Our reference: RC245775

s92 - Request for Further Information

I have reviewed your resource consent application **RC245775** to construct, operate and maintain a solar farm and battery energy storage facility. More information is needed so that I can better understand your proposal and its potential effects.

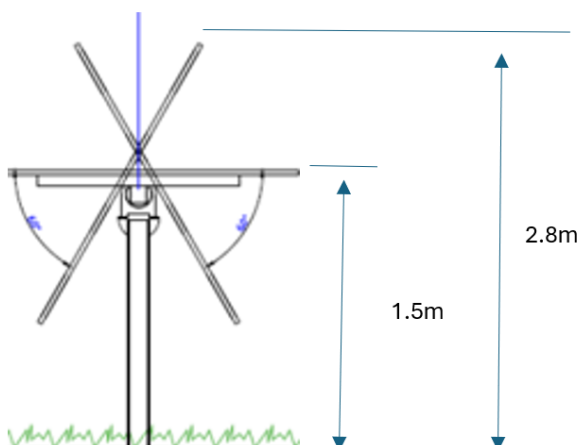
There is limited detail on the type of Solar panels, apart from noting that they are single axis trackers. The type of drive mechanism is important as this can impact the farm management programme. The layout of them is also important for the movement of vehicles.

13. Please provide further information to address these matters.

Figure 1 Proximity of LLRZ land to application site

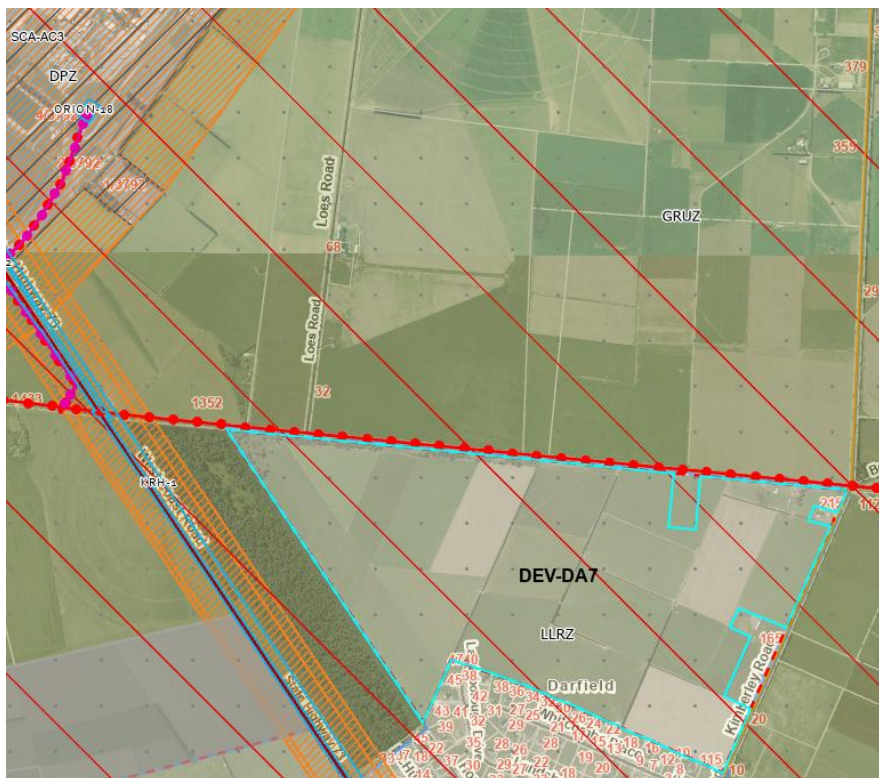
It is noted that Lot 2 DP 460046 (highlighted in blue in Figure 1 below) is zoned Large Lot Residential Zone and is located within 250 metres of the panel. In the event that the proposal is granted, any future residential development of this site will be subject to Rule EI-R3.1.a.iv whereby any new residential development within 250m of “any noise generating infrastructure used for renewable electricity generation is a discretionary activity (Rule EI-R3.3).

22. Please provide further information regarding the potential reverse sensitivity issues for this Development Area

It is also noted that the owners of Lot 2 DP 460046 have provided affected party approval for the proposal, but that the information they were provided with may not have clearly identified this potential future impact on the development of this area.

Figure 2 Water Races

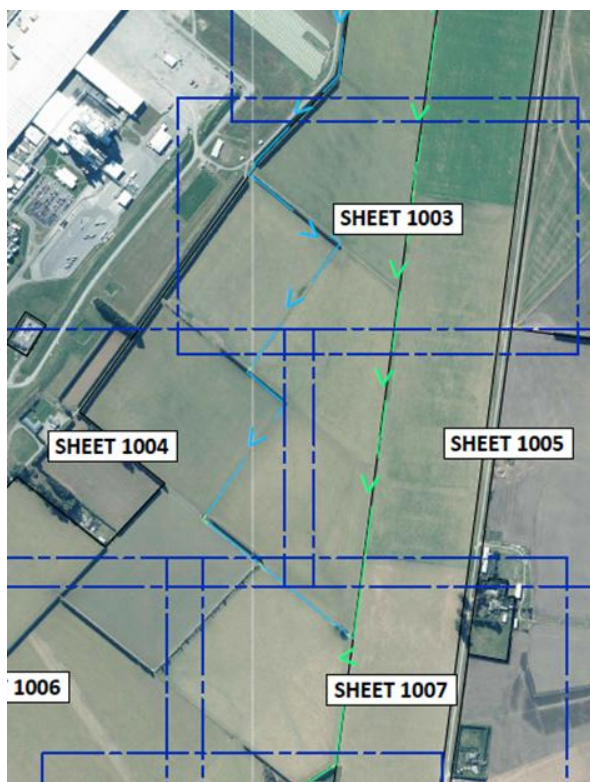
28. Please advise how Water Race bylaw requirements will be met for the north–south water race (identified in light green in **Figure 2** below).

It is not clear if the east-west water race has been factored into the design. This race is along the western border of the property from Auchenflower Road (mapped within Stormwater Management Plan included in the application), and enters the property 1km south of Auchenflower Rd, flowing into the other race that has been included in the plans (flowing straight from north to south).

29. Please confirm that the required 5 metre setback will be provided for the east – west water race (identified in light blue in **Figure 2** above, and noting that it follows a slightly different path from that identified in the plan) – noting that while the water race may be located with the Fonterra site in places, the setback will still apply.

Figure 2.1 Austroads Guide for turn bay warrant (reproduced from TA)

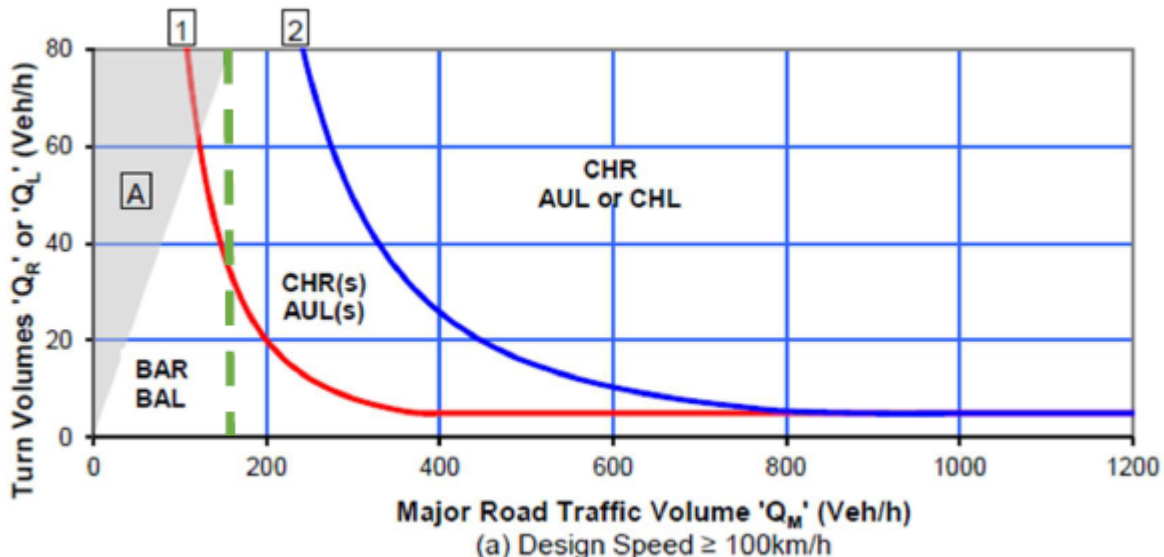
1. Section 5.3.3 of the Transport Assessment (TA) concludes that right-turn mitigation at the SH73/Homebush Road intersection is unnecessary, despite high turning volumes that typically require right-turn treatments. This conclusion is based on the impact being limited to the construction phase. Instead, the TA recommends maintaining a Traffic Management Plan to limit right-turn volumes to a maximum of 80 vehicles per hour.

We disagree. Right-turn movements exceeding approximately 35 vehicles per hour would typically warrant a Channelised Right Turn treatment with a short turn slot (CHR(S)), as shown in Figure 2.1, and volumes below this level warrant a rural basic right turn (BAR).

Please clarify why 80 vehicles per hour has been assumed as the maximum threshold for right turns at the SH73/Homebush Road intersection. Also, confirm whether minor works (e.g., repositioning limit lines or minor seal widening) are required to enable a through vehicle to safely pass a right-turning vehicle in the live lane.
